STAFF REPORT

REGIONAL CENTER HEARING EXAMINER - HIGH IMPACT CASE

Case Number	2026-REG-041
Address (approx.)	951 S White River Parkway, West Drive
Location	Center Township, Council District #18
Petitioner	Justin Kingen
Zoning	C-S (RC)
Request	Regional Center Approval to provide for construction of a surface parking lot that is over 20,000 square feet.

Landscape Plan

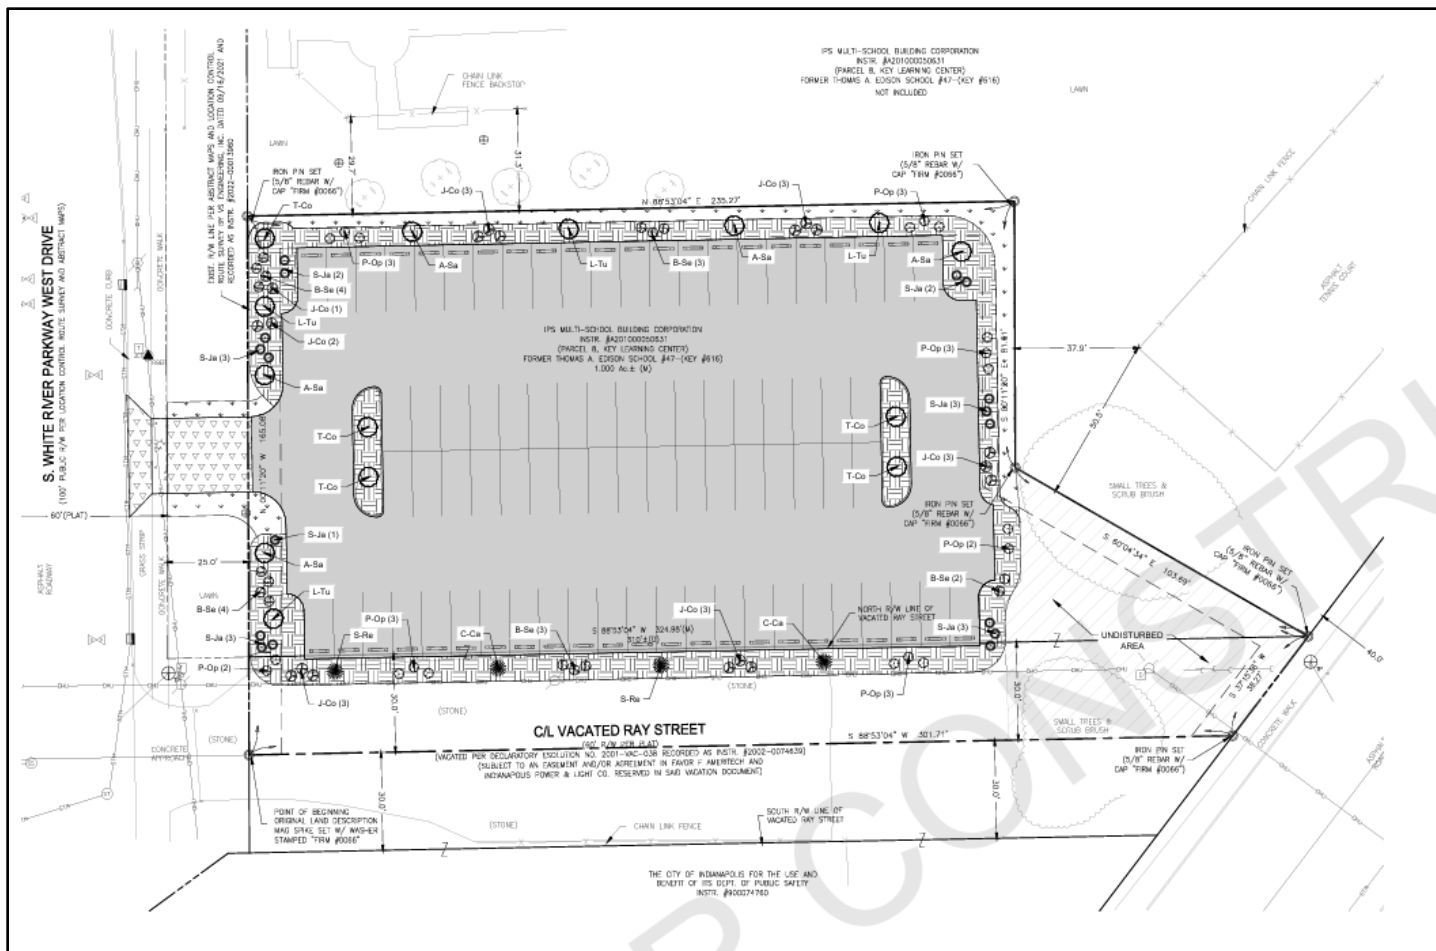
4. The trees and shrubs proposed are inadequate. The petitioner shall work with City staff for input on appropriate tree and shrub species and submit a revised landscape plan for staff review and approval. Guideline 4.6.4 applies.

6. A marked pedestrian crosswalk shall be provided between the parking lot and the Biltwell to ensure safe pedestrian access. Guideline SC 3.2.2 applies.

7. A pedestrian walkway shall be provided to connect the existing public sidewalk to the parking lot to provide a safe and accessible pedestrian route. Guideline SC 3.2.4 applies.
8. A marked pedestrian crosswalk shall be provided within the parking lot to connect the walkway to the landscaped island. Guideline SC 3.2.2 applies.
9. The proposed aisle width shall be revised to comply with the zoning ordinance, which requires a minimum aisle width of 23 feet.
